# ***SIREN EP HOTLINER***

## ***TECHNICAL NOTICE***

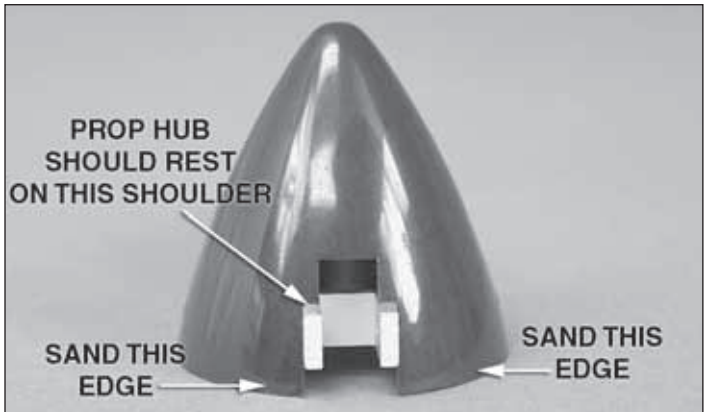
If the spinner interferes with the fuselage/cowl, you may need to sand the rear edge of the spinner to make it fit. It may be necessary to remove some material from the rear edge of the spinner before it fits without contacting the fuselage. The spinner is correctly mounted when the “shoulder” of each cutout rests on the prop hub AND the rear edge does not contact the fuselage at any point when the propeller is rotated.
